# **HINKLEY POINT C**

## Expert Statement to the EIA

REPORT  
REP-0413

The Austrian Federal Environmental Agency “Umweltbundesamt” has assigned Oda Becker, scientific consultant, to elaborate an expert statement on the documents presented by the UK.

Figure 1: Time Line Post Accident Management (SBO at Power States)

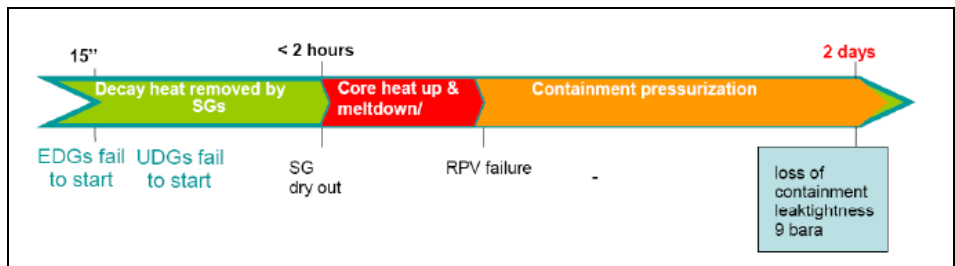
According to the Stress Tests for Olkiluoto 3, in case of SBO, if countermeasures were unsuccessful, the uncovering of the core would take place within 3 hours with extensive fuel damage within 4 hours and pressure vessel melt-through within 7 to 8 hours after an accident starts (ENSREG 2012).

Figure 1 illustrates the resulting Time Line for Post Accident Management (SBO = Total Loss of AC Power for Power States) (UK EPR 2011, 16.6).

Figure 2: Caesium-137 deposition after a severe accident at Hinkley Point B

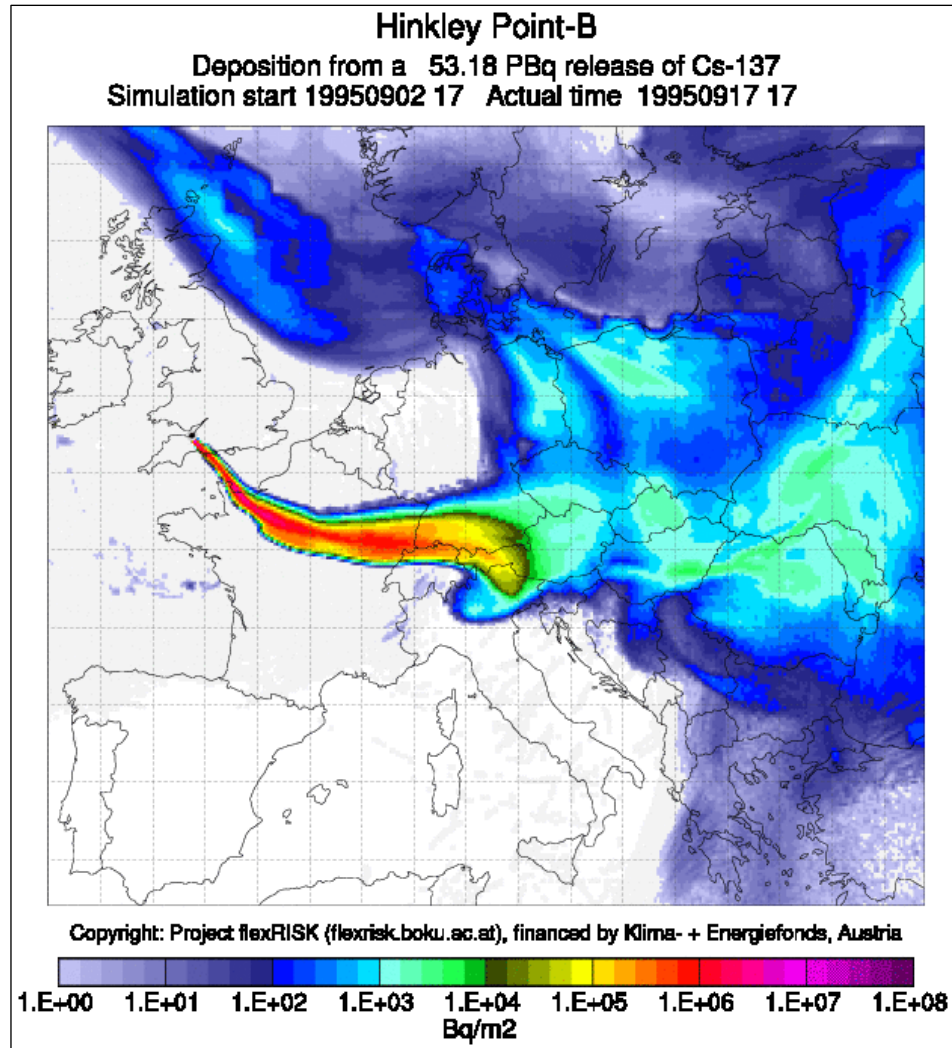
For a potential caesium-137 release of 53.18 PBq at Hinkley Point NPP under conditions comparable with those on September 2, 1995, a considerable contamination of the Austrian territory would result. Most parts show depositions of about 1E+03 Bq/m<sup>2</sup>. However, in some areas the values are between 1E+04 and 1E+05 Bq/m<sup>2</sup>, even up to 2E+05 Bq/m<sup>2</sup>.

If a contamination of ground (and air) beyond certain thresholds can be expected, a set of agricultural intervention measures is triggered. These measures include earlier harvesting, closing of greenhouses and covering of plants, putting livestock in stables etc. For these measures, Austrian and German authorities defined a threshold for caesium-137 ground deposition of 650 Bq/m<sup>2</sup> (SkkM 2010; Ssk 2008). These agricultural measures are quite complex and take some time. Reactions are especially difficult if there is only very little time between the onset of an accident and the arrival of the first radioactive clouds (FLEXRISK 2013b). For the calculated scenario, ground depositions of all areas are higher than this threshold, i.e. Austria would be highly affected.

Figure 2 shows that Austria and many other countries (including Germany and Switzerland) could be affected by a severe accident at Hinkley Point C.
